CITY OF YORK
LOCAL PLAN
Site Selection Paper Addendum
September 2014

Non-Strategic Site Addendum **Page 19**

SUBMITTED SITE PLAN

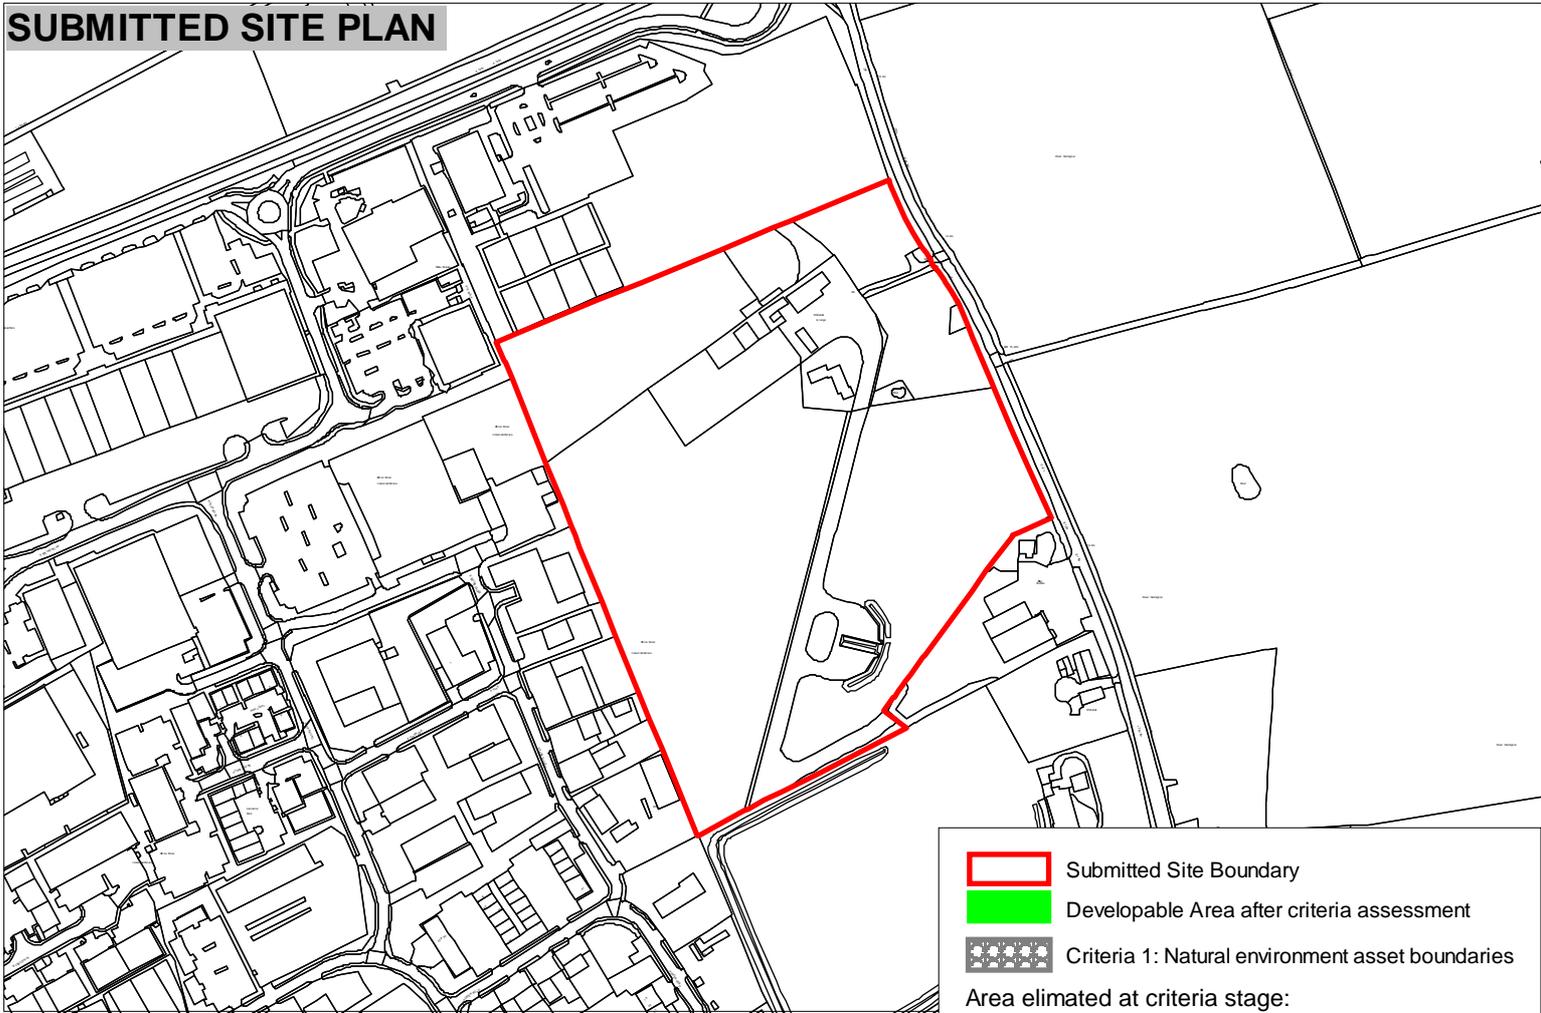
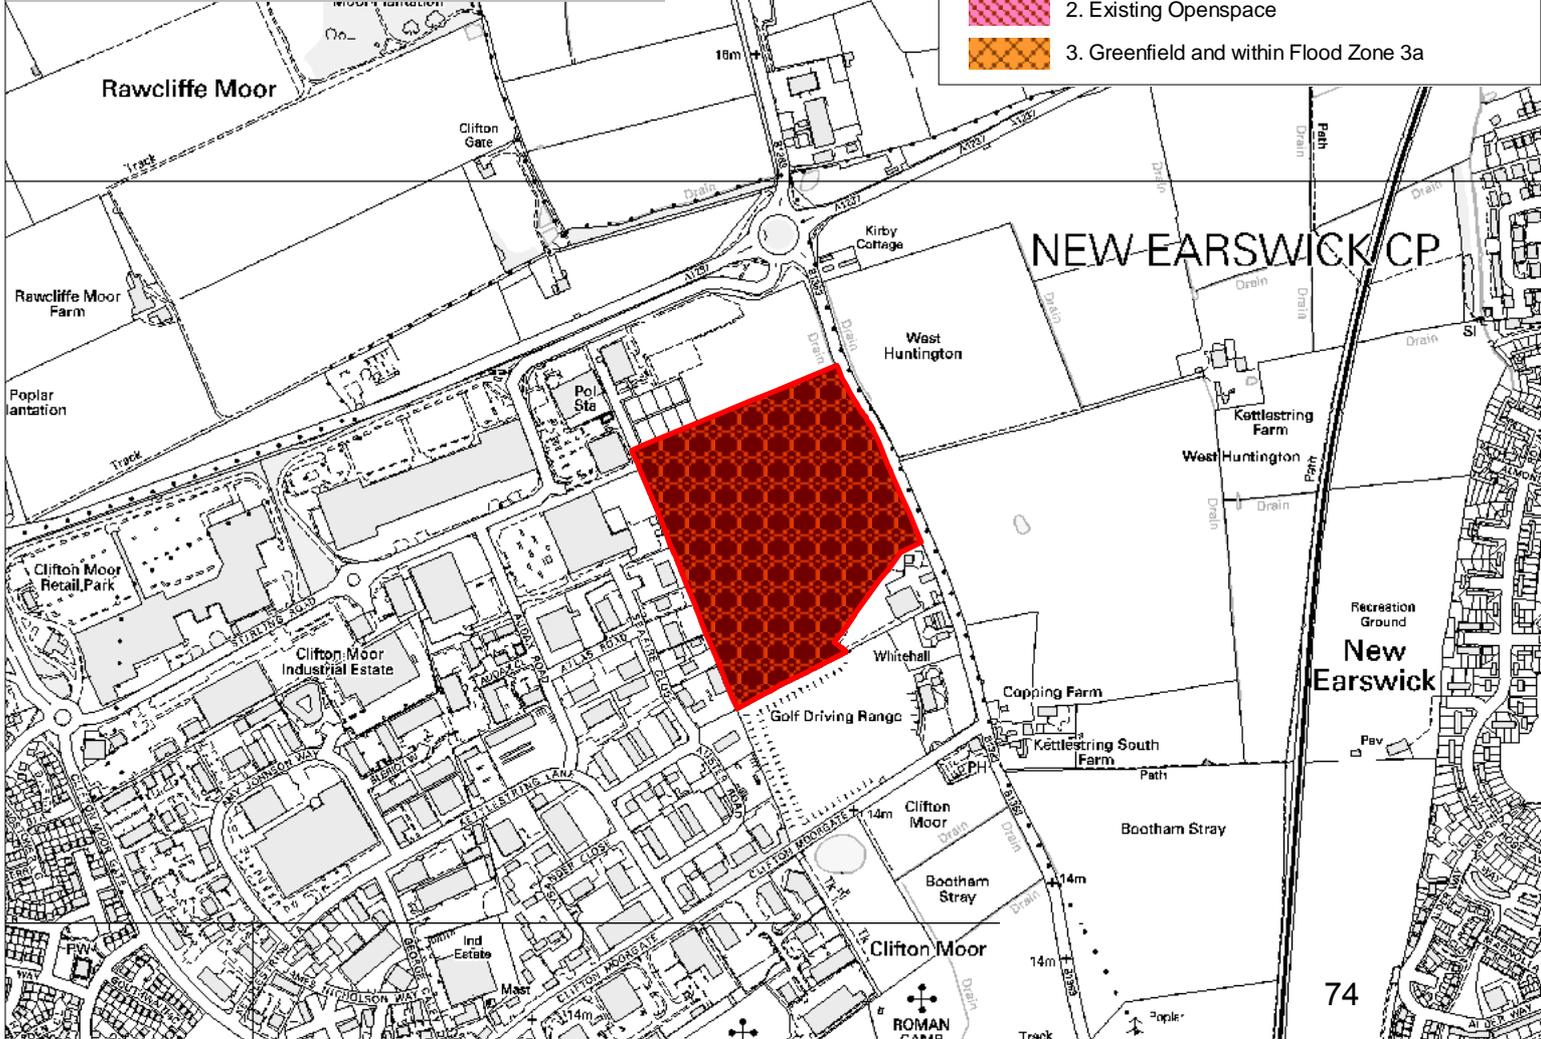
ID Ref:	ID6326
New site ref:	
Original Site Ref Number:	246
Allocation Ref:	
Site Name:	Whitehall Grange
Submitted for:	Employment
Agent:	Keogh Planning
Response submitted by:	Eamonn Keogh
On behalf of:	Landowner
Additional Evidence Through FSC:	No
Summary of Response Received:	Object to failure of site at FSC due to compromising the historic character and setting of York. Autohorn Limited have a requirement for a strategic site for car storage. Further justification submitted as to why it would not compromise HC&S. Refer to park and ride decision and the officer analysis on landscape issues.
Flooding/Drainage:	No additional comments to FSC. This site is split between greenfield and brownfield. Change in this location would require the applicable run-off rates. GREEN
Landscape Comments:	This site is located within the Green Wedge as designated in the historic Character and Setting Assessment. Development in this location would erode the green wedge and is not considered suitable for development. No further evidence submitted and original comments remain unchanged.

Retail Comments:	N/A
Proposals Map Action Required:	N/A
Trajectory implications:	N/A
ID:	23
Officer Recommendation:	Development of the site would compromise the green wedge and it is not considered suitable for allocation for employment uses. The comments given by Economic Development Unit are recognised and the need to support expansion of existing businesses but on balance it is considered that the site is not suitable for allocation in the Local Plan in 72

this sensitive location.REJECT - NO CHANGE
